Subject: Request for Site-Specific Design of Stabilization Measures in Selected High-Hazard Portions of the Route of the proposed Atlantic Coast Pipeline Project in the Monongahela National Forest and George Washington National Forest
OEP/DG2E/Gas 4
Atlantic Coast Pipeline, LLC
Docket Nos. CP15-554-000 and CP15-554-001

U.S. Forest Service Request for Site-Specific Design of Stabilization Measures in Selected High-Hazard Portions of the Proposed Atlantic Coast Pipeline Route

MNF Site 1 (Attachment A)

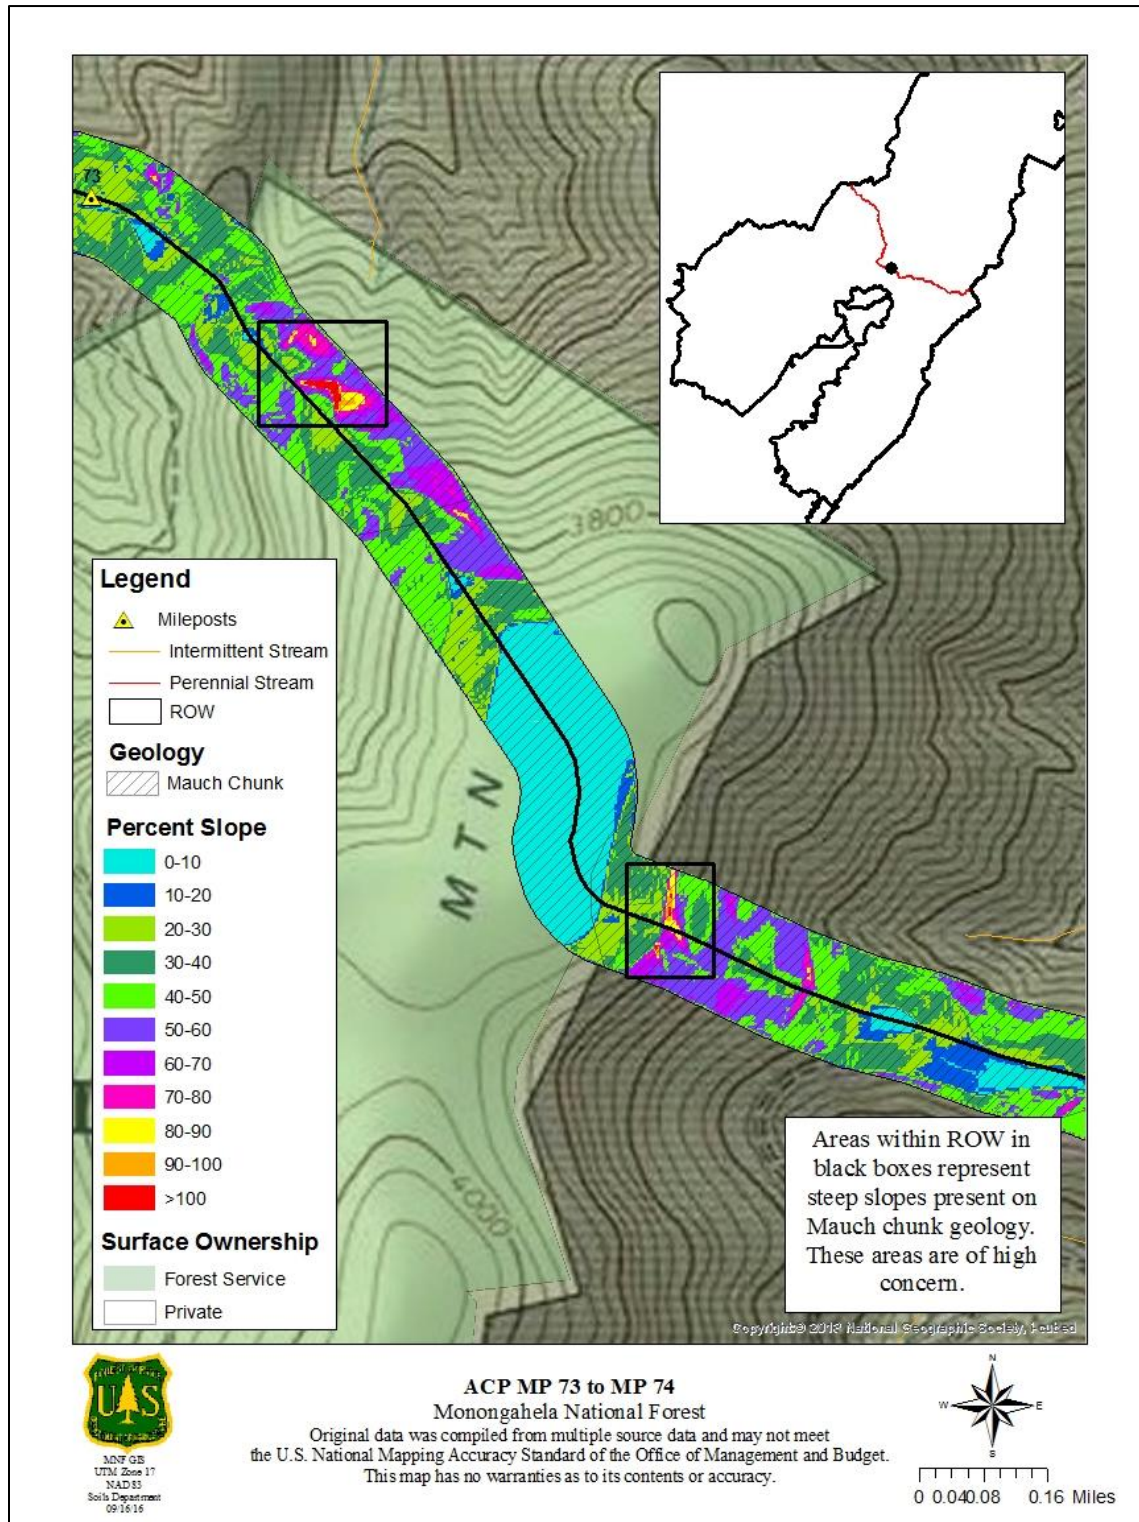
Between ACP's Mileposts 73 and 74 where the buffered ROW will cross areas with slopes of 80-90, 90-100, and >100% and which are also present on Mauch Chunk geology. This area of concern is presented on public land and also on private land.

Attachment B:

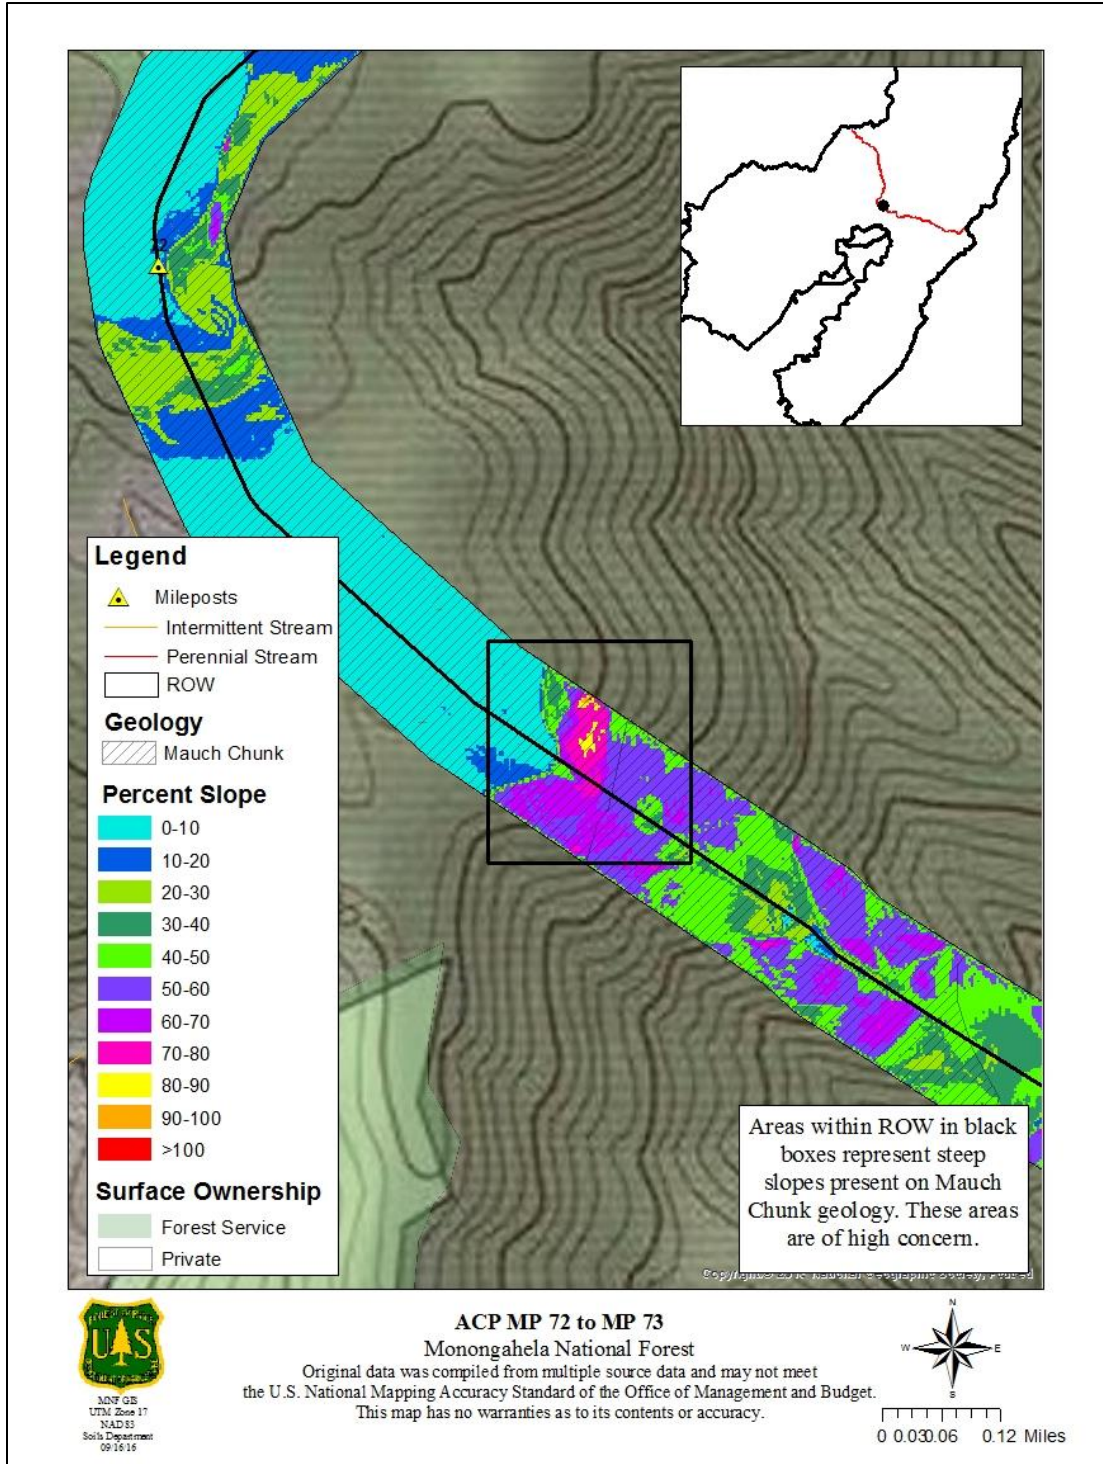
Between ACP's Mileposts 72 and 73 where the buffered ROW will cross areas with slopes of 60-70, 70-80, and 80-90%. These areas are also present on Mauch Chunk geology on private land.

Attachment C:

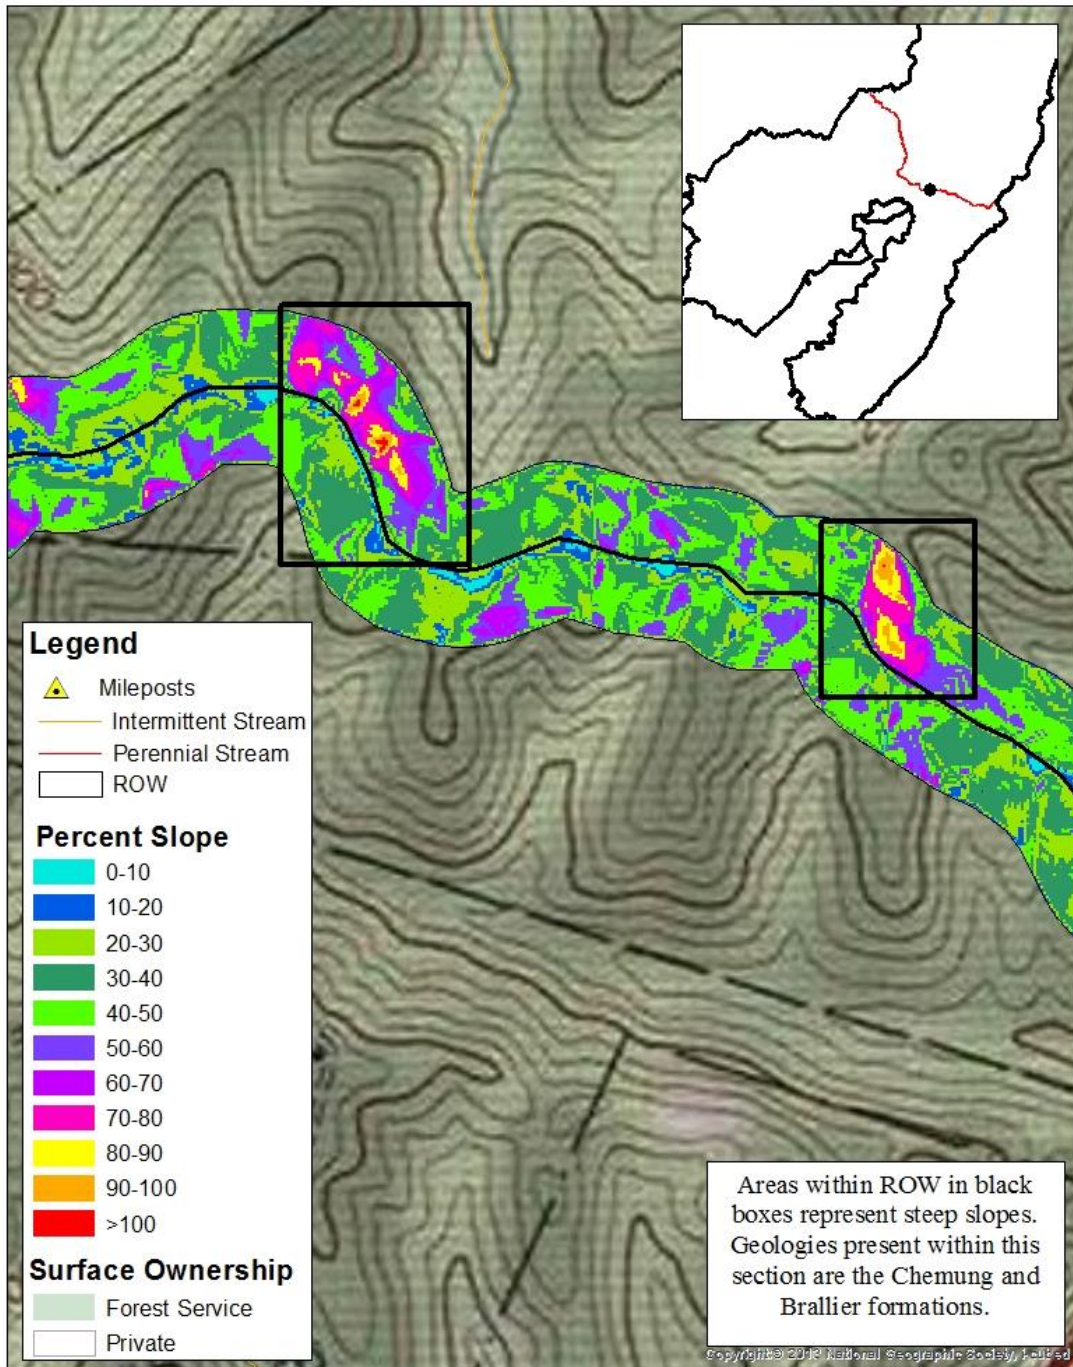
Between Mileposts 78 to 79 where the buffered ROW will cross areas with slopes 70-80, 80-90, 90-100, and in some cases >100%. These areas are present on Chemung geology but still pose a risk on steep slopes. These areas of concern are present on private lands.

Attachment D:

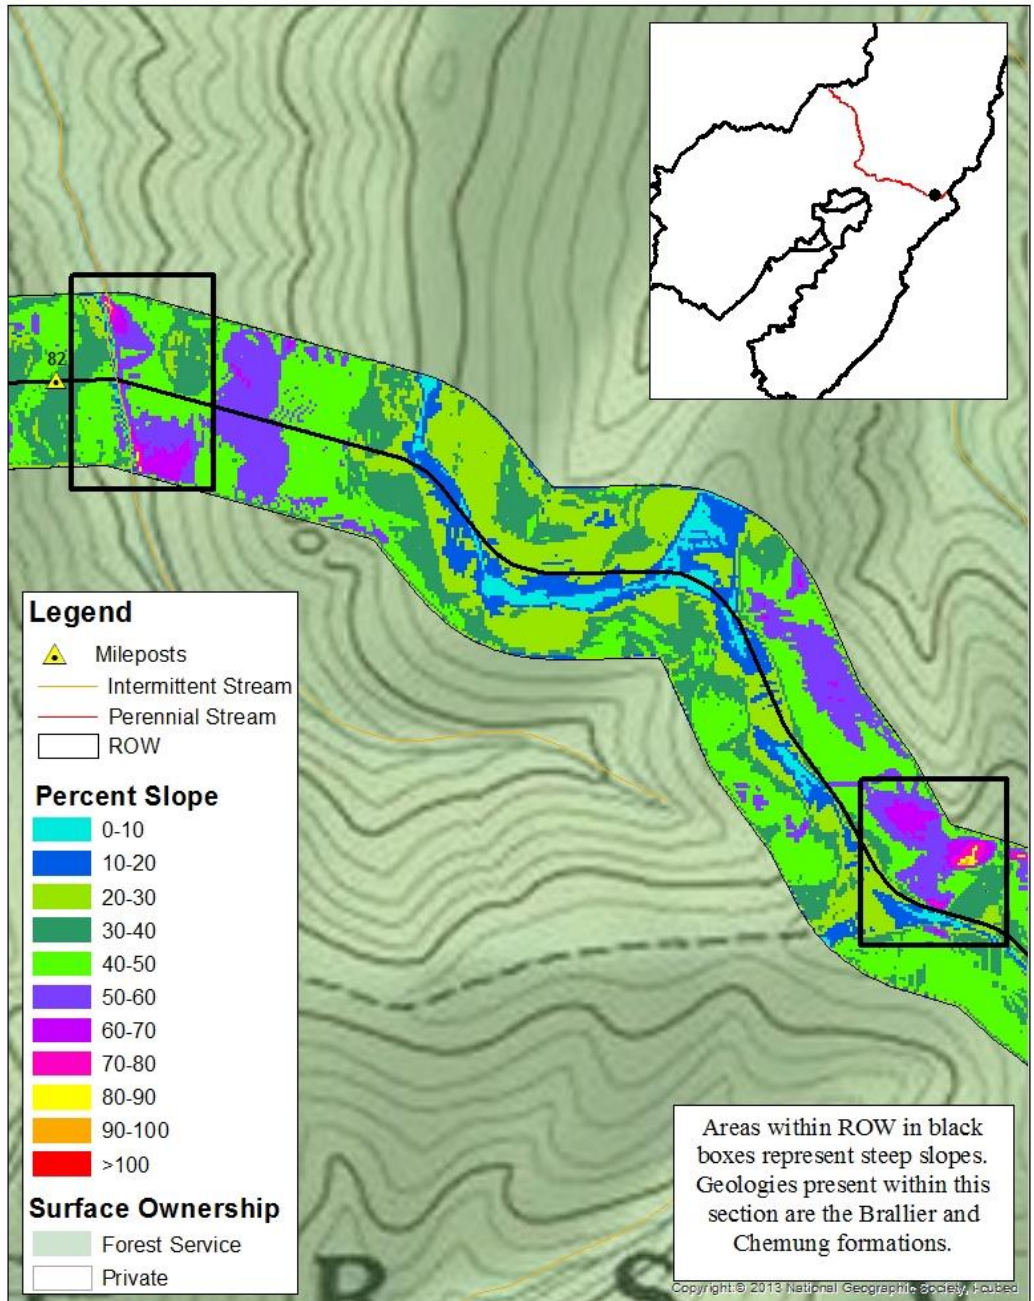
Between Mileposts 82 and 83 where the buffered ROW and centerline intercepts an intermittent stream, 60-70, 70-80, and 80-90% slopes. These areas of concern are present on public land.
